South Texas Project Electric Generating Station P.O. Box 289 Wadsworth, Texas 77483

January 17, 2011  
U7-C-STP-NRC-110008

South Texas Project  
Units 3 and 4  
Docket Nos. 52-012 and 52-013  
Response to Request for Additional Information

Attached are responses to NRC staff questions included in Request for Additional Information (RAI) letter numbers 349 and 350 related to Combined License Application (COLA) Part 2, Tier 2, Sections 3.7 and 3.8. The attachments address the responses to the RAI questions listed below:

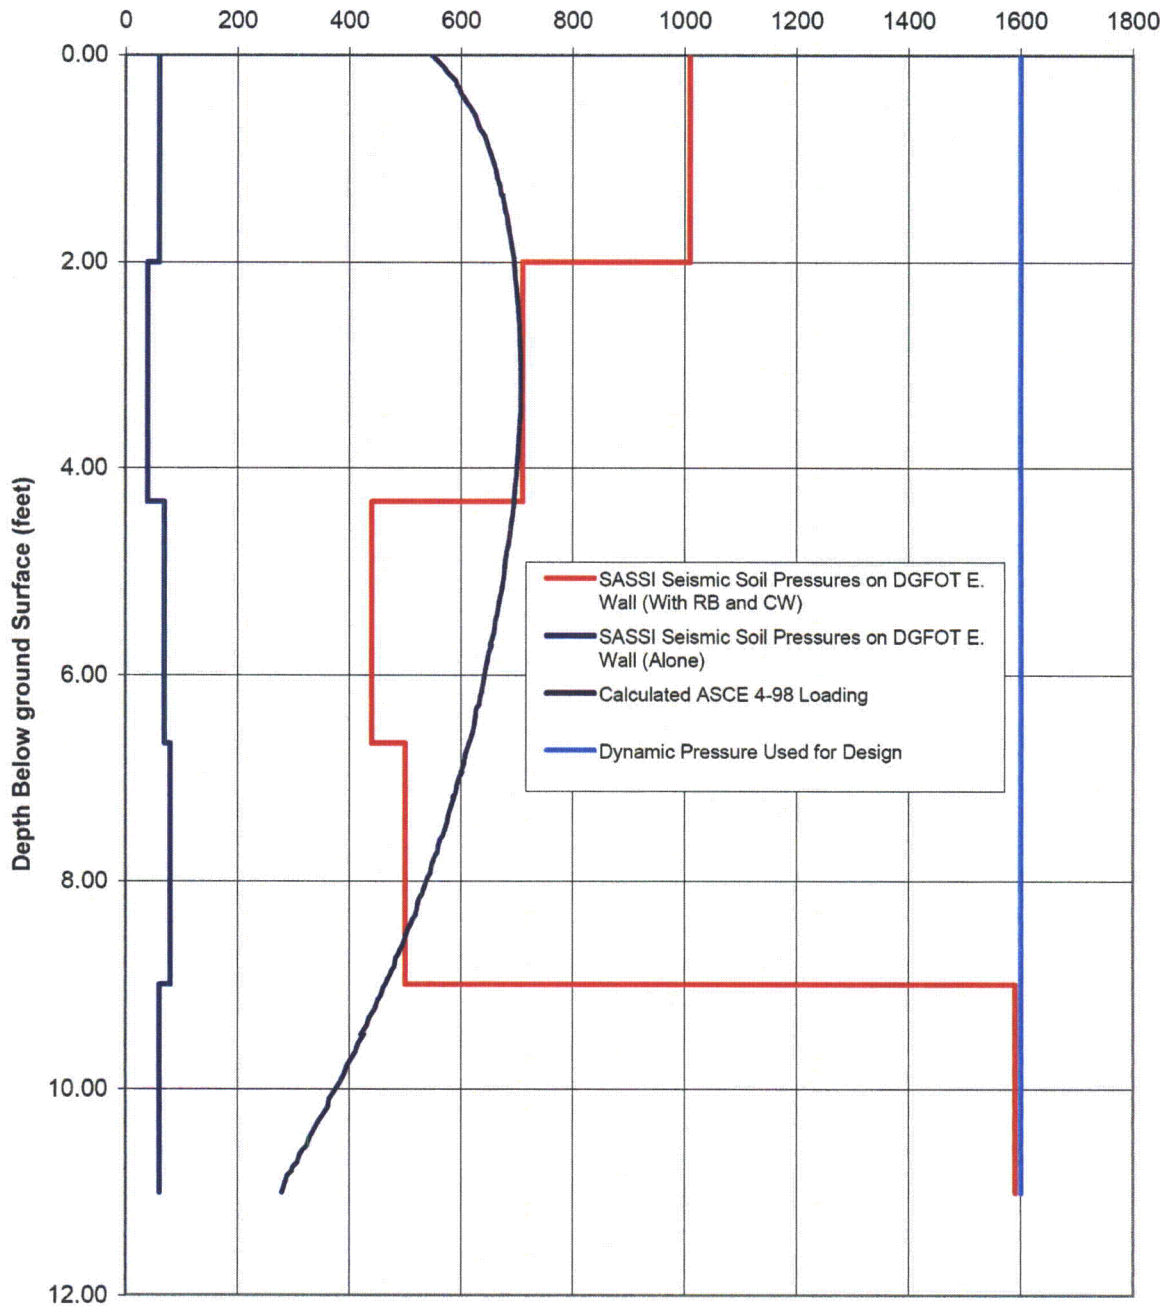
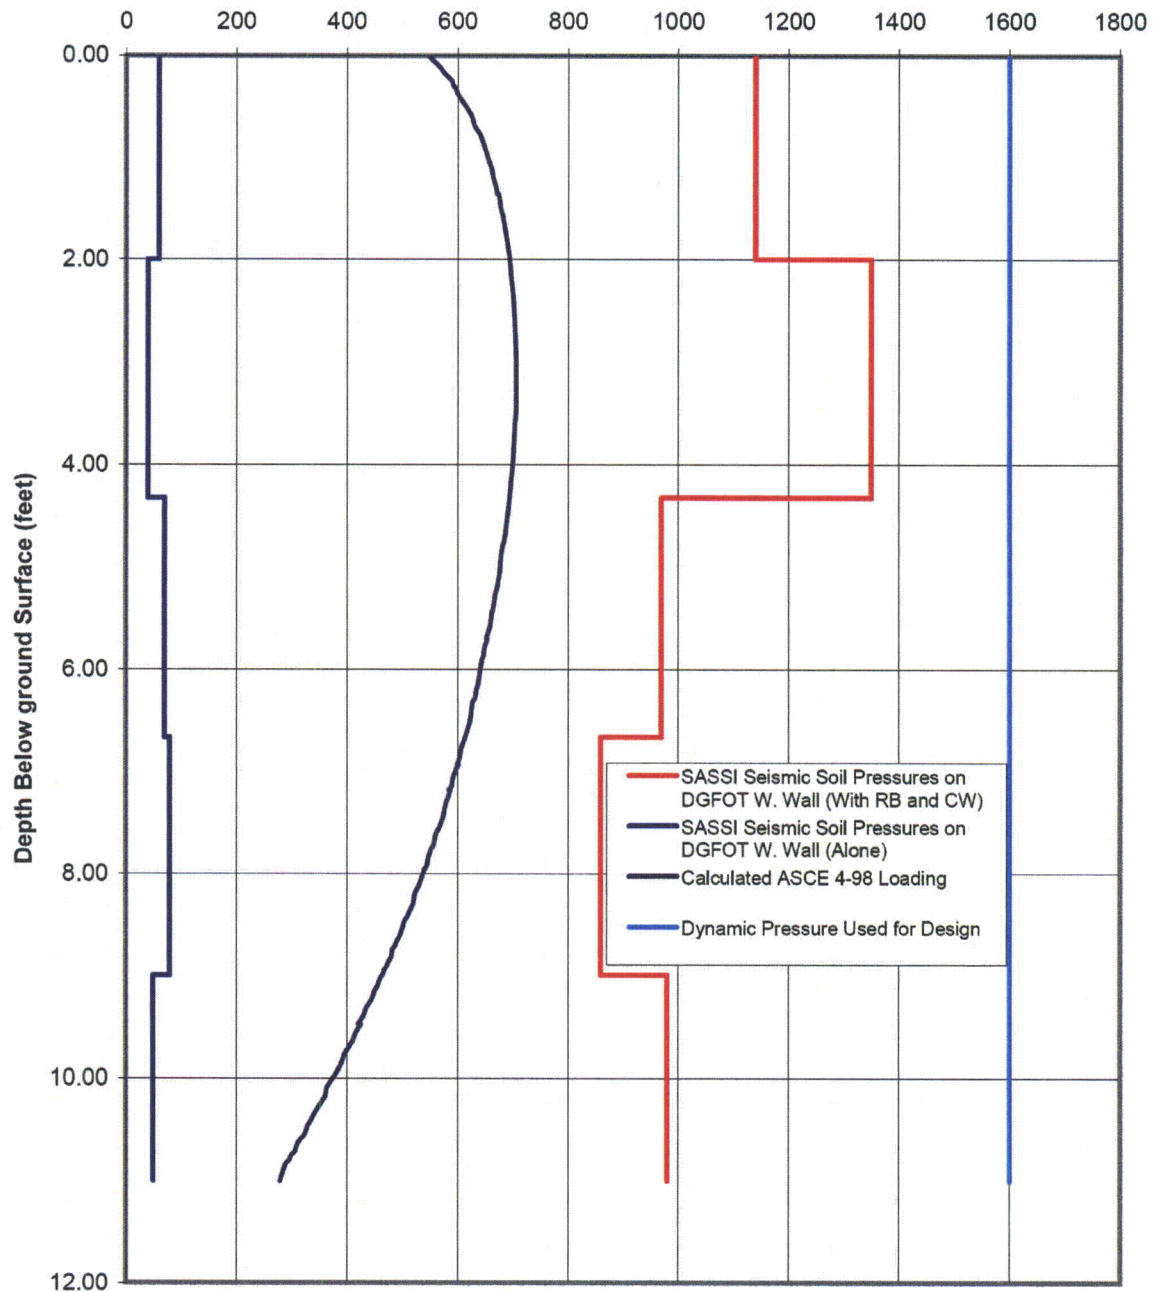
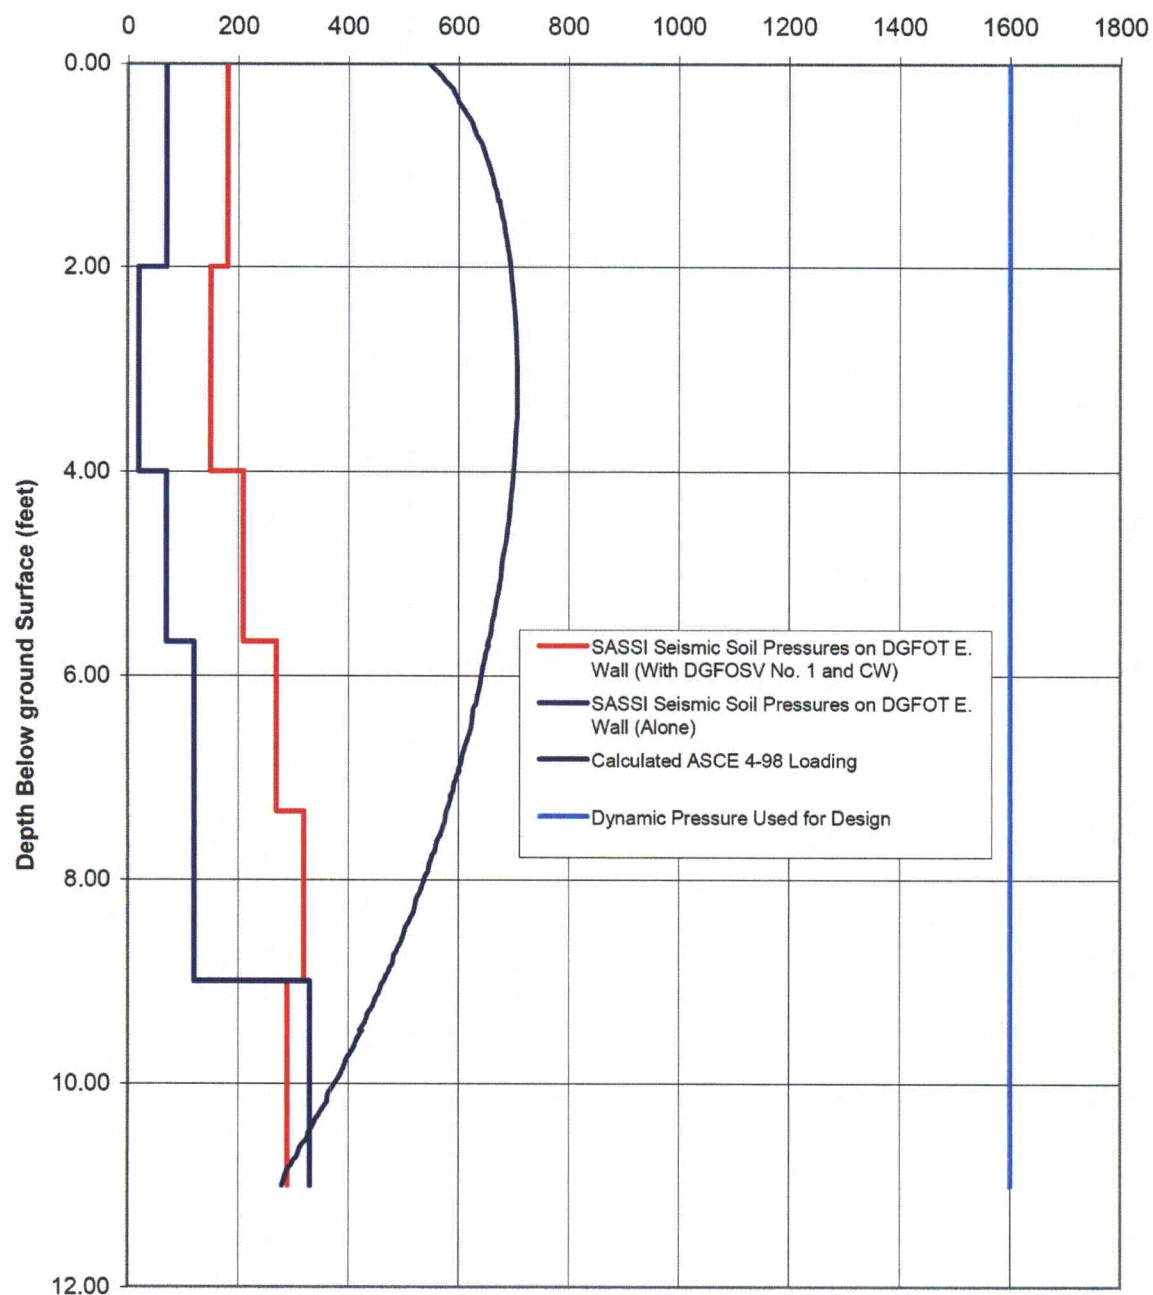
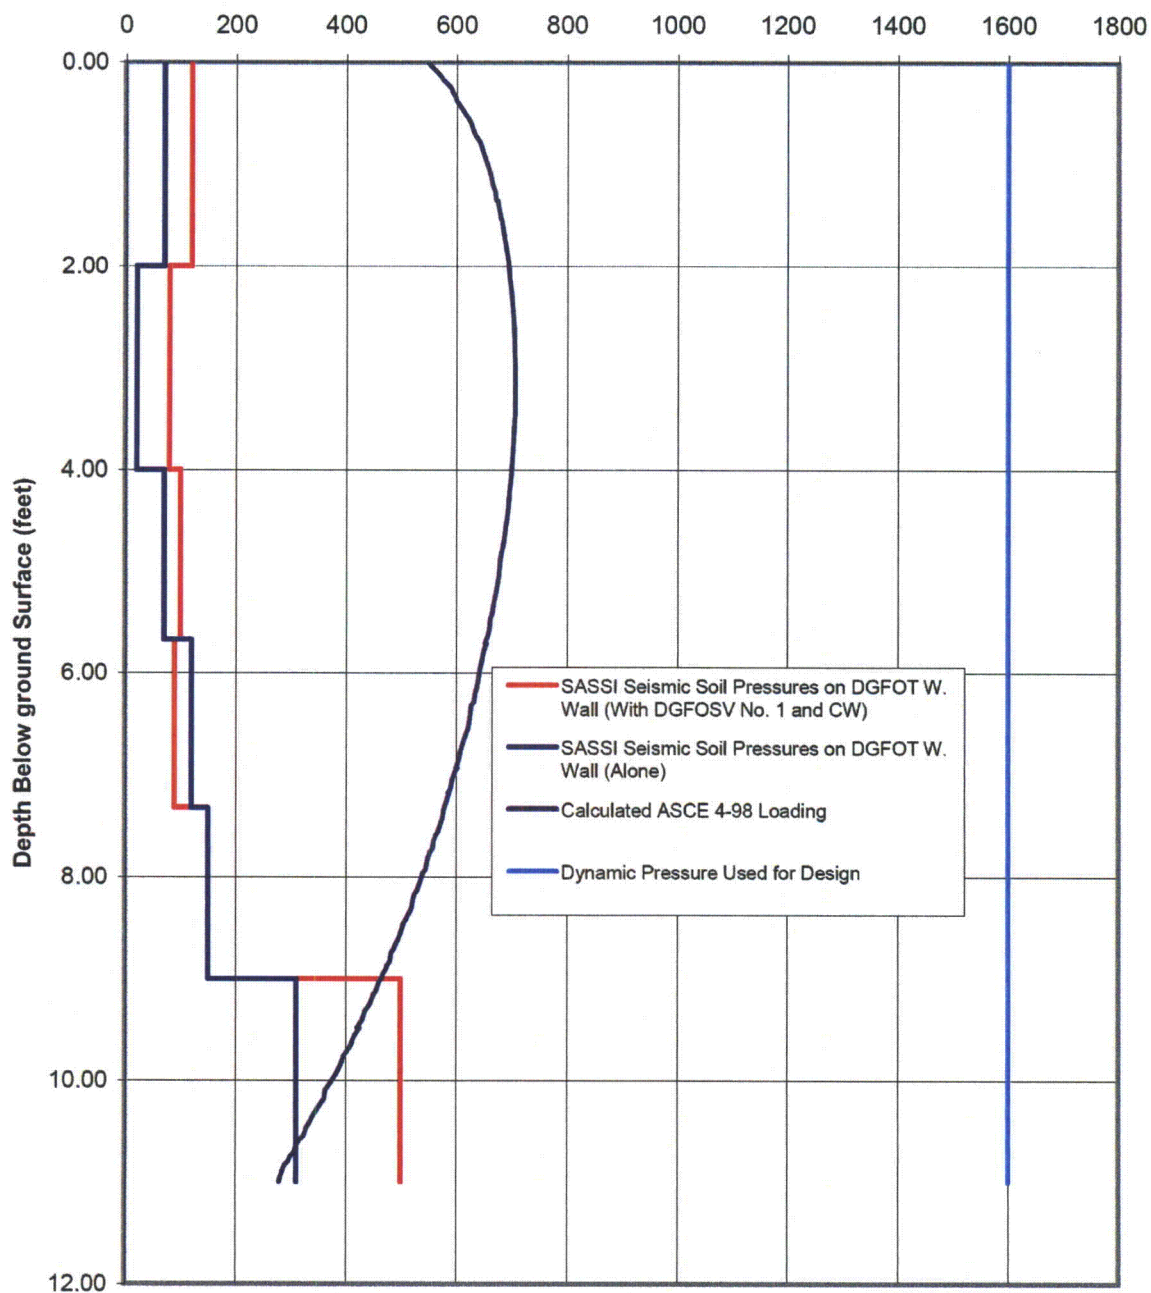
- (c) Demonstrate that the DGFOVS foundation response spectra and dynamic soil pressure (on DGFOVS basement walls using ASCE 4-98 criteria) used in the design of DGFOVS will envelop the results of structure to structure (SSSI) interaction analysis which explicitly models DGFOVS structure in the SSI model of RB and the RSW Pump House structure.

Figures 3H.7-5 through 3H.7-8 show a comparison of the SSI, SSSI, ASCE 4-98 seismic soil pressures and the enveloping seismic soil pressures used for the design of the DGFOT walls.

Figure 3H.7-20: 2D Model for SSI Analysis of a Typical Cross section of DGFOT

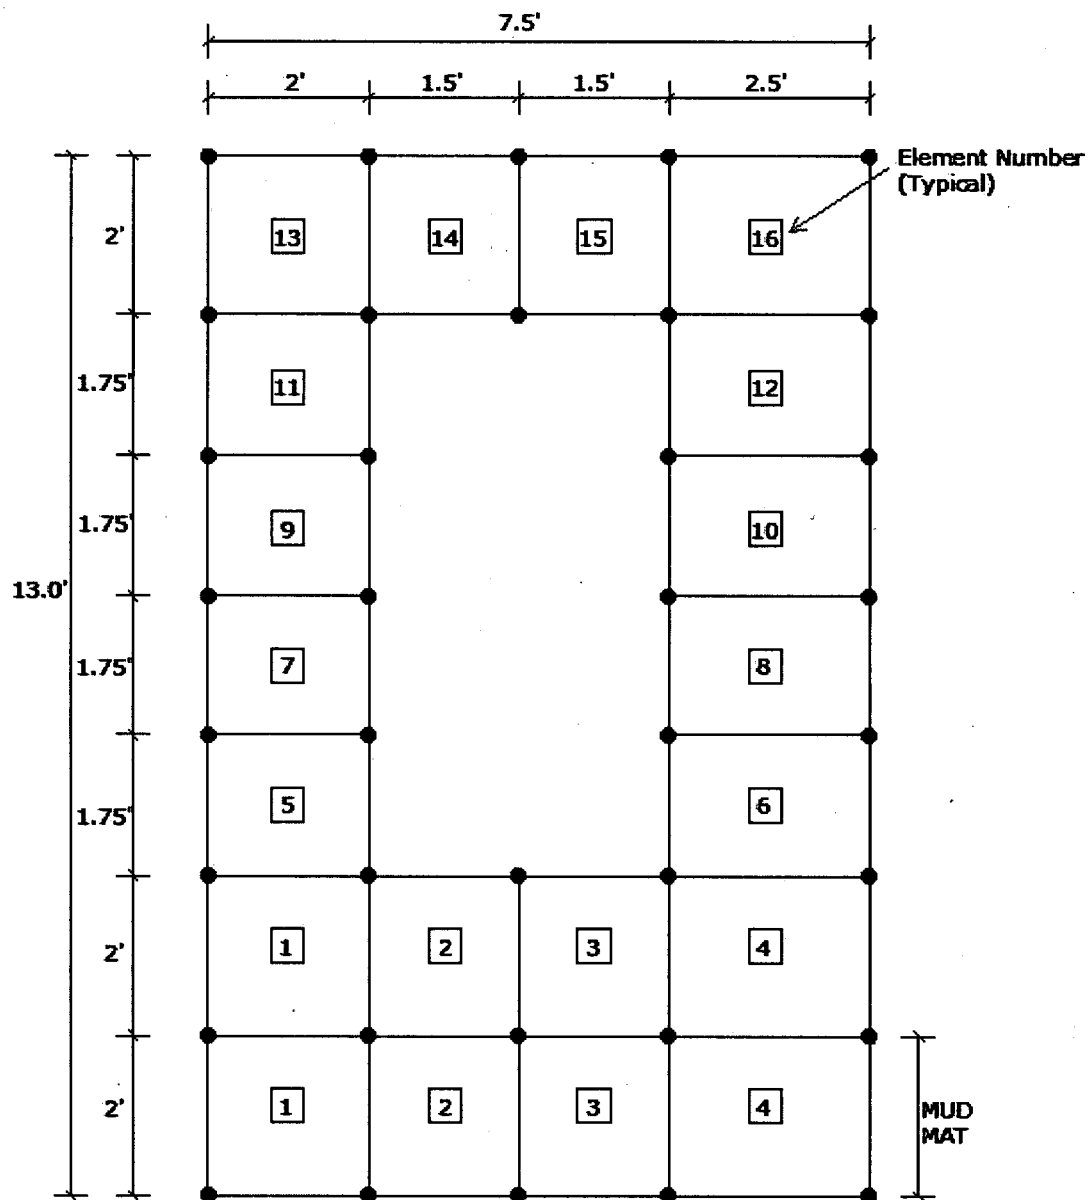
- (a) Describe in detail the method used for the SSI analysis of DGFOVS including the procedures for treatment of strain dependent backfill material properties in the model, input motion used and how it is specified in the analysis, variation of soil properties, and the computer programs used for SSI analysis.

SASSI2000 computer code is used for the SSI analysis, using the direct method. Figure 3H.7-20 shows the structural part of the 2D plane-strain model of the DGFOT with 2 ft thick mud mat under the base mat. The top of the tunnel is at the grade elevation. The specifics of the 2D SSI model are as follows:
